Review of “B1” to “C1” interface Response to NCR 3735 and Deviation Request to Address Remaining B-C Coil Interfaces

B1 - C1 Fit-up 12/18/07

Disposition to NCR 3735

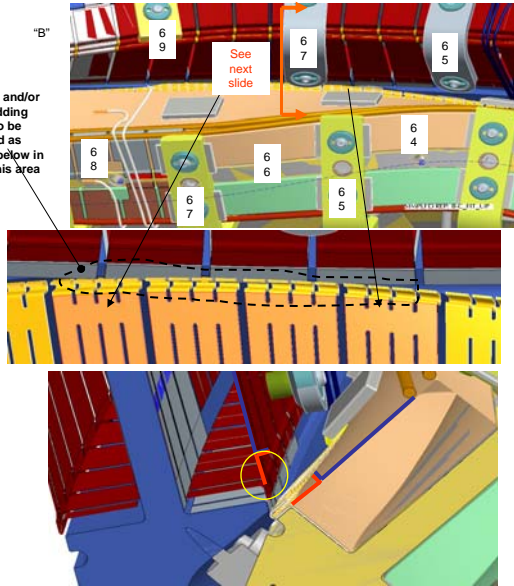
Elimination of cladding interference:

On B coil, between clamp holes 65 & 69; and on C coil, between clamp holes 64 & 68:

- Unbend copper crimps & straighten copper.
- Form the copper as shown in the yellow circle. Bent out leg should be $\sim 1/8"$.
- Form the upper copper to meet the bent out leg and form a crimp U section over the lower piece.
- Crimp the copper U.
- Epoxy the copper to the coil and overlay the repaired region with glass - epoxy.

Every attempt should be made to avoid copper breakage. However IF the copper breaks during the unbending operation, abandon that piece. Uncooled continuous lengths up to 8' are acceptable. Record the actual as repaired condition and append to the NCR.

The "B" and/or "C" cladding needs to be modified as shown below in red in this area

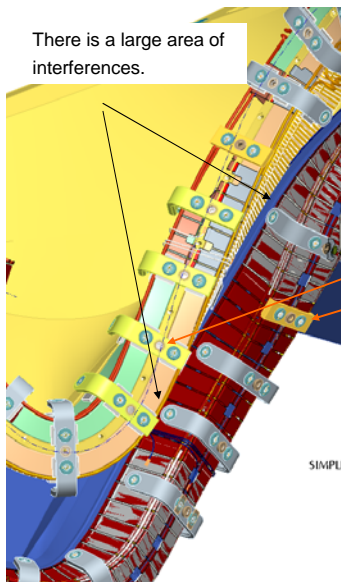
There is a large area of interferences.
